Editor's note: add new clause 142A.2 after existing clause 142A.1.

142A.2 LDPC FEC Encoder Test Vectors

Figure 142A-1 LDPC FEC encoder test vector locations

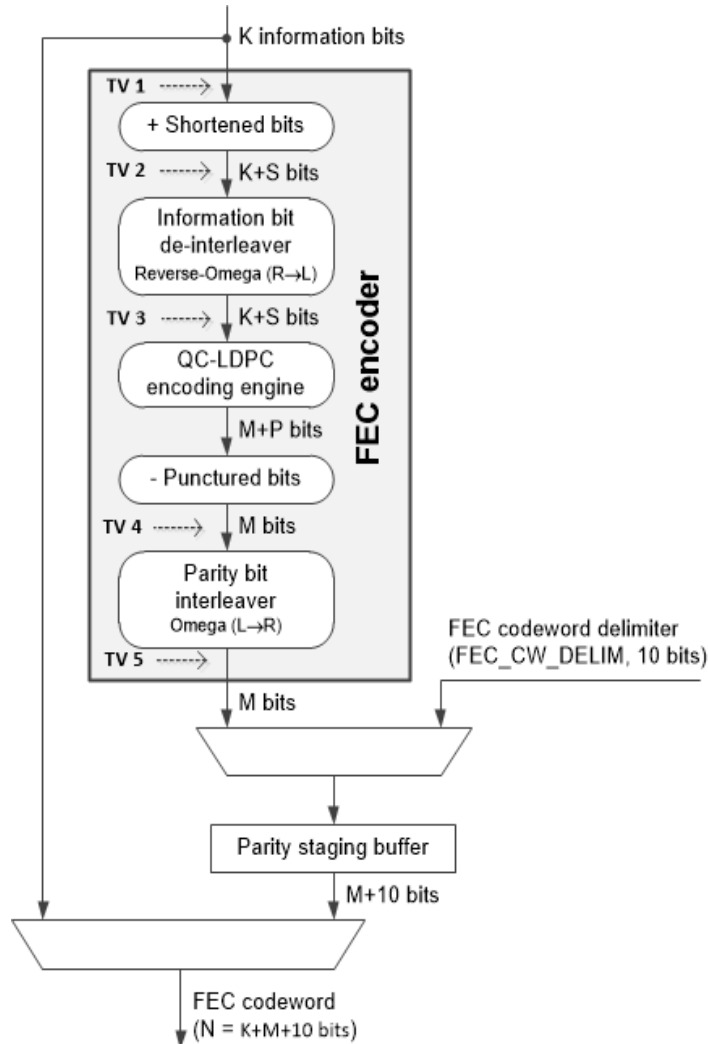
Five test vectors are provided to assist in the implementation and verification of the FEC encoder and interleaver as presented in 142.4. The locations of each of the vectors in the processing path relative to Figure 142-6 are shown in Figure 142A-1.
